W.O. No. 06720-002-005

RE: CORRECTION OF WATER LEVEL DATA TABLES AND MAPS
L.E. CARPENTER REMEDIAL INVESTIGATION

Subsequent to the submittal of the report entitled **"Final Supplemental Remedial Investigation Addendum for L.E. Carpenter and Company"**, errors were discovered in Tables 3-1 and 3-2 of the report for three wells. The errors are in the corrected water level elevations for monitor wells MW-6, MW-10 and MW-11S. For your convenience, I have enclosed revised versions of these tables and the corresponding equipotential maps. The changes can be summarized as follows:

626.5
624.5
0 50' 100'
Approximate Scale
WESTON
L.E. CARPENTER AND CO.
WHARTON, NEW JERSEY
EQUIPOTENTIAL MAP OF THE SHALLOW AQUIFER ZONE MEASURED ON 27 FEBRUARY, 1992.
FIGURE 3-13
DATE
REVISION
From Original by GEOENGINEERING

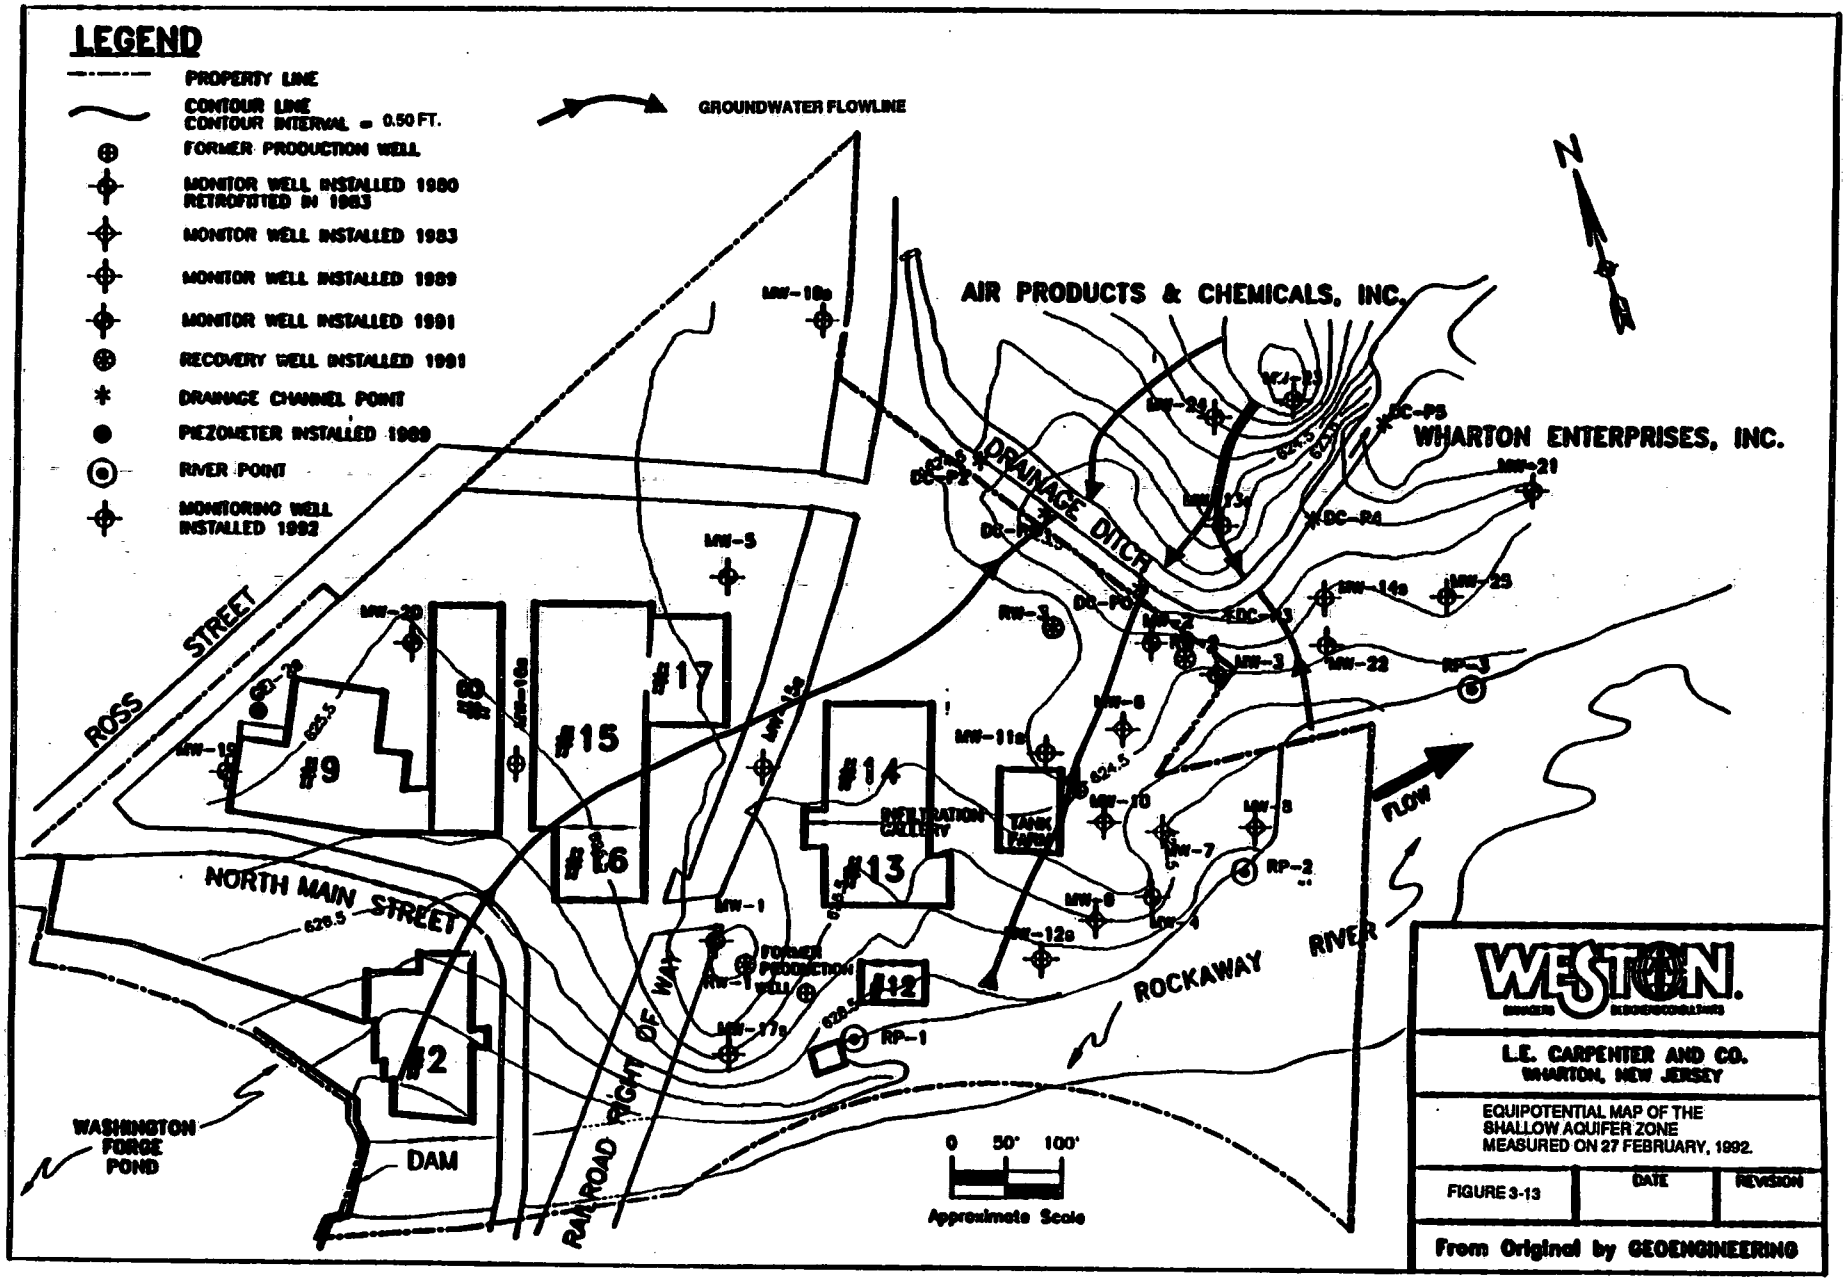
You will note that these changes have the effect of reducing the large mound in the equipotential surface near the central portion of the site. Since these data sets were not used in generating the mean shallow aquifer zone equipotential map for 1991, Figure 3-15 is unaffected by these changes. Furthermore, these changes do not affect the conclusions regarding the overall flow patterns at the site (i.e., the Rockaway River is still a recharge boundary and shallow groundwater discharge still occurs along the Air Products drainage ditch.
